CITY PLAN COMMISSION STAFF REPORT

Project Name Skyview Residential

Request CD-CPC-2023-00017

- Rezoning with Plan (Preliminary Plat)

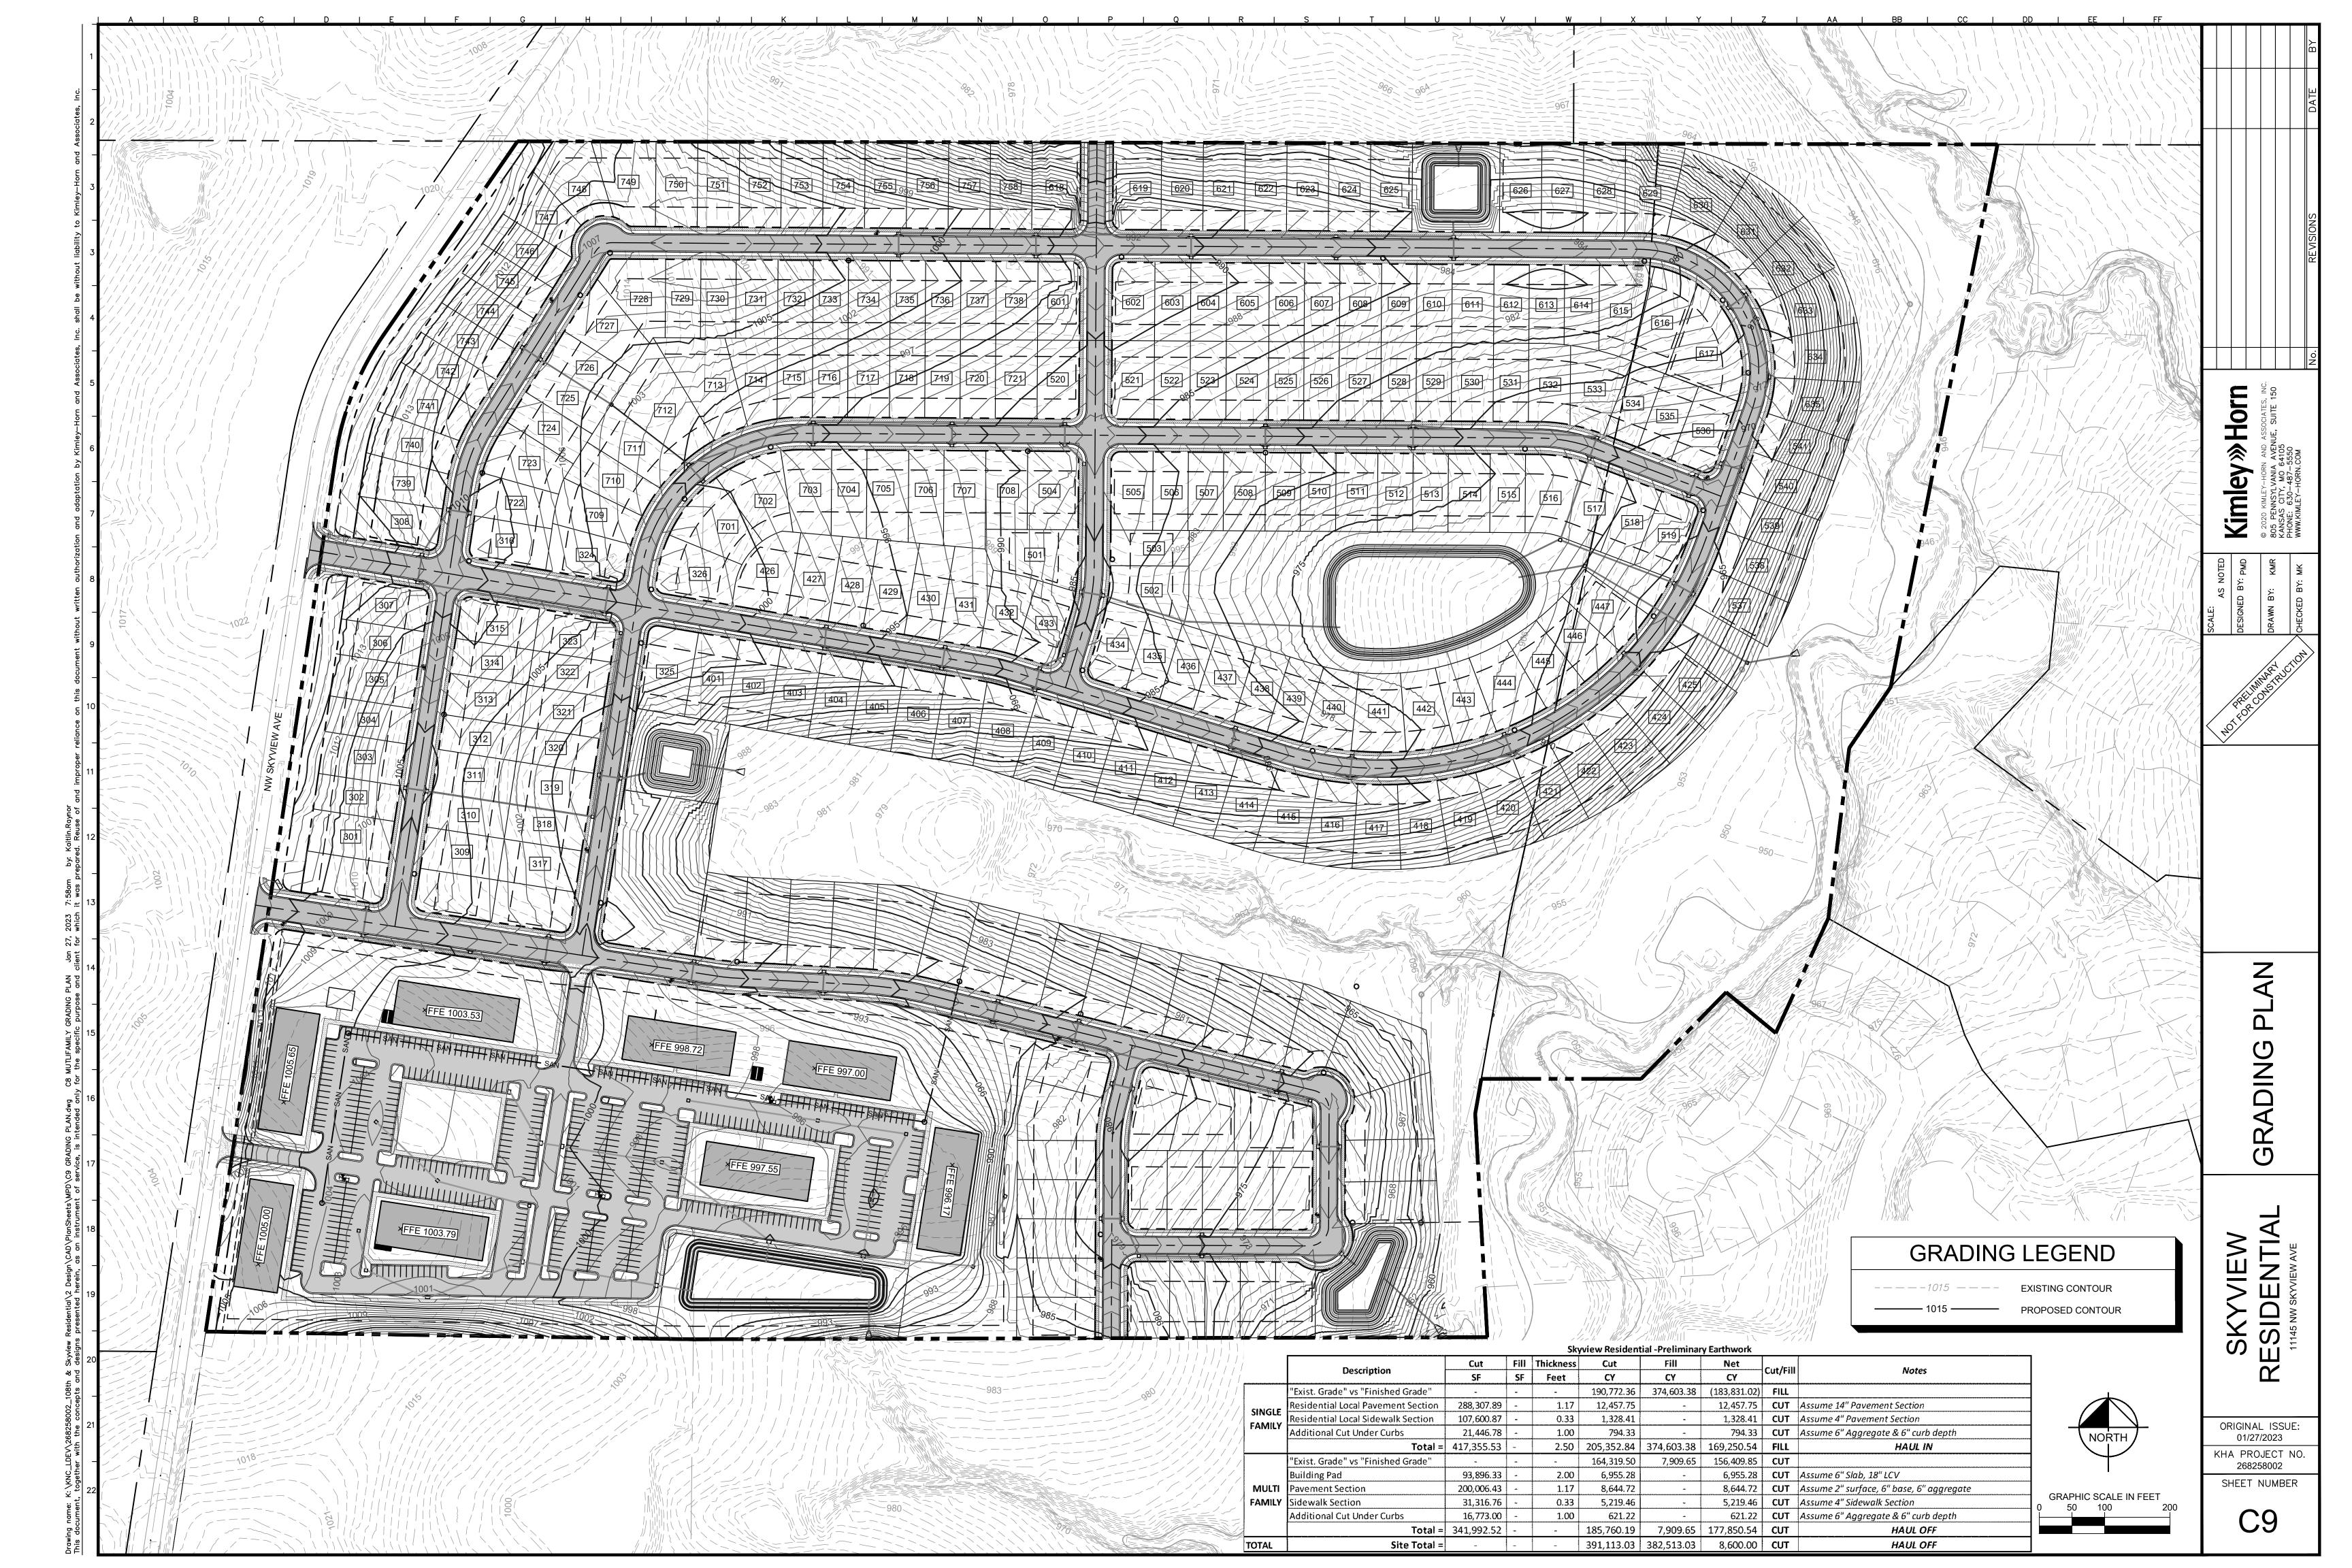
- 27. 3. The developer shall submit an analysis by a registered Professional Engineer in Missouri to verify adequate capacity of the existing water supply mains for the new domestic and fire demands, and if necessary, prepare improvement plans to meet the anticipated demands.
- 28. The developer must submit water main extension drawings prepared by a registered professional Engineer in Missouri to the main extension desk for review, acceptance and contracts per the KC Water Rules and Regulations for Water main extensions and Relocations.
 - (https://www.kcwater.us/wp-content/uploads/2022/05/2022-Rules-and-Regulations-for-Water-Main-Extensions-Final2.pdf).
- 29. Please make Fire Hydrant symbology better visible throughout the utility sheet.
